UNITED STATES PATENT AND TRADEMARK OFFICE

APPLICATION NO.	FILING DATE	FIRST NAMED INVENTOR	ATTORNEY DOCKET NO.	CONFIRMATION NO.
10/671,273	09/24/2003	Chin-Hsien Yen	JCLA9302	6552
23900	7590	04/20/2005	EXAMINER	
J C PATENTS, INC. 4 VENTURE, SUITE 250 IRVINE, CA 92618			ENGLUND, TERRY LEE	
			ART UNIT	PAPER NUMBER
			2816

DETAILED ACTION

FIG. 1A (PRIOR ART)

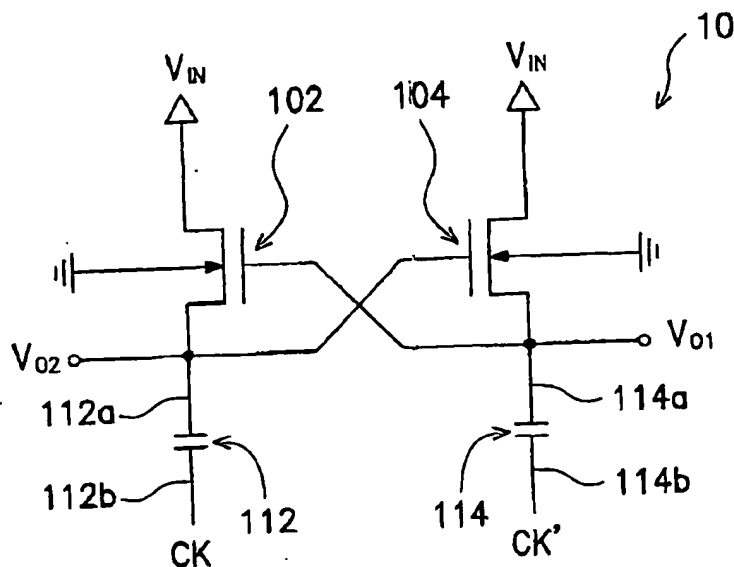
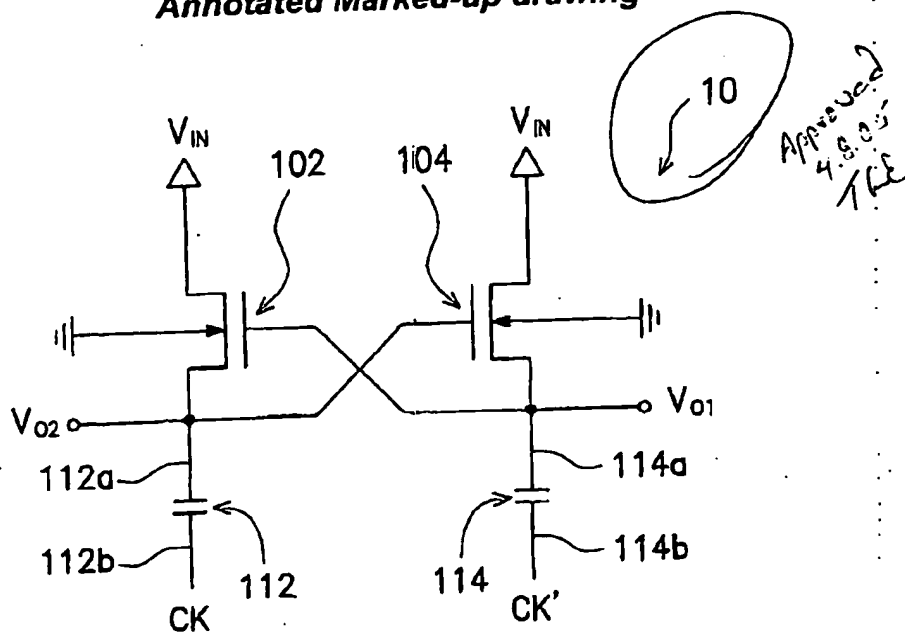
Although the drawing change to Fig. 1A, and a change to the disclosure with respect to Fig. 4, overcame the objections with respect to Figs. 1A and 4 lacking the reference signs "10" and "440b", respectively, the other drawing objections described on page 2 of the previous Office Action were not addressed/corrected. Therefore, the "10"/"440b" objections have been withdrawn, but the other objections are maintained. These remaining objections are repeated later under the appropriate section.

Not
Approved
4.8.05
TLE

FIG. 1B (PRIOR ART)

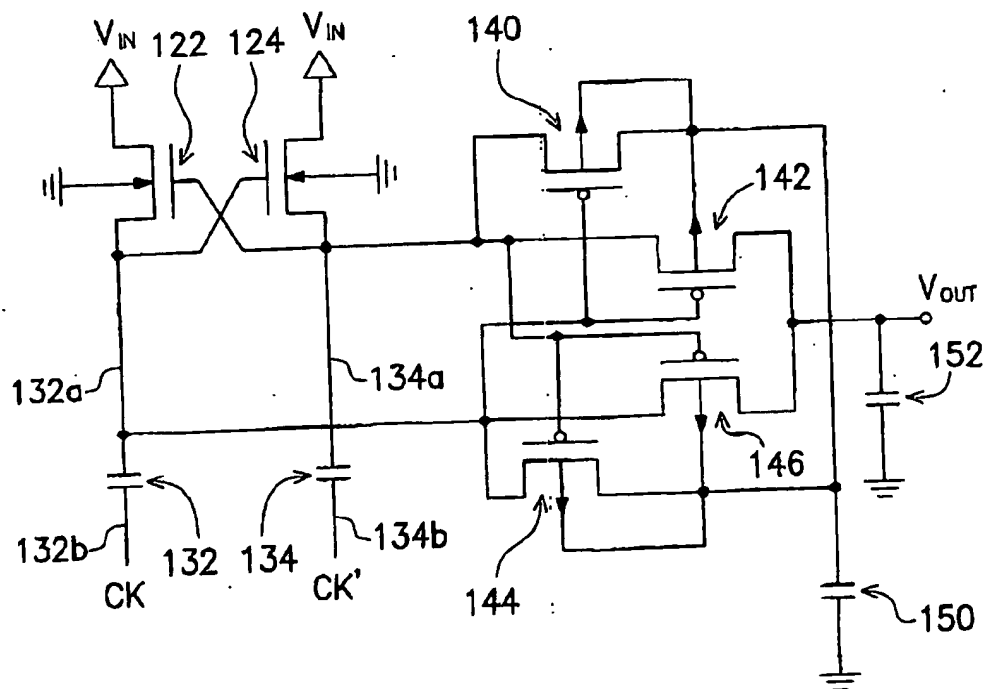
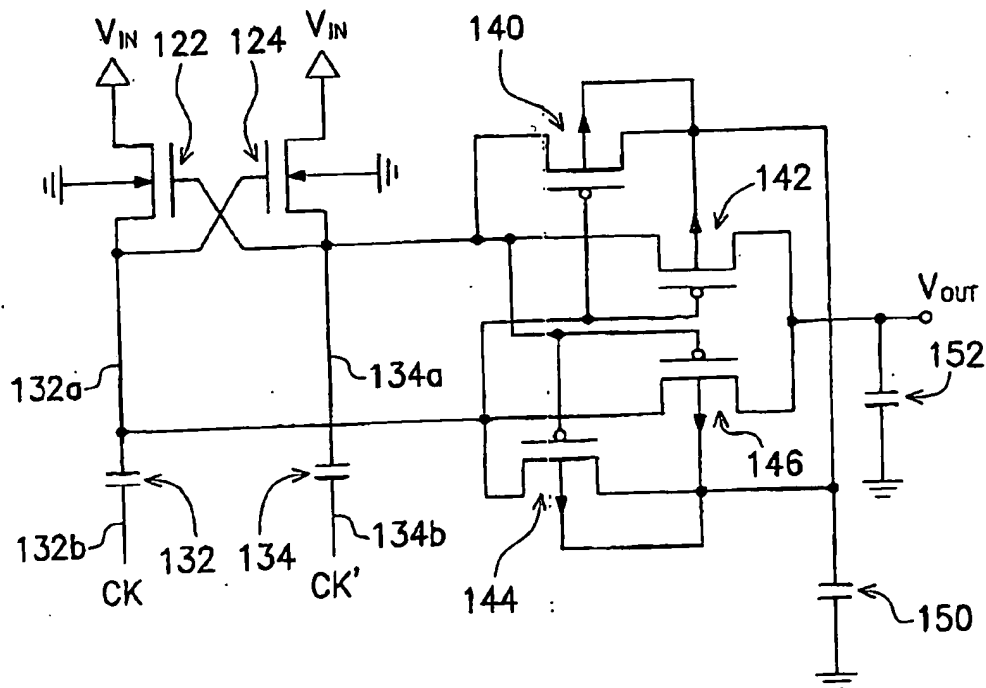
The drawings remain objected to as failing to comply with 37 CFR 1.84(p)(5) because they include the following reference character(s) not mentioned in the description: 132, 132a, 132b, 134, 134a, 134b, and 140-152 with respect to Fig. 1B; 32, 302, 304, 308, 322, 330, and 332 with respect to Fig. 3; and 502-508, 512-518, 530, and 540 with respect to Fig. 5. Corrected drawing sheets in compliance with 37 CFR 1.121(d), or amendment to the specification to add the reference character(s) in the description in compliance with 37 CFR 1.121(b) are required in reply to the Office action to avoid abandonment of the application. Any amended replacement drawing sheet should include all of the figures appearing on the immediate prior version of the sheet, even if only one figure is being amended. The replacement sheet(s) should be labeled "Replacement Sheet" in the page header (as per 37 CFR 1.84(c)) so as not to obstruct any portion of the drawing figures. If the changes are not accepted by the examiner, the applicant will be notified and informed of any required corrective action in the next Office action. The objection to the drawings will not be held in abeyance.
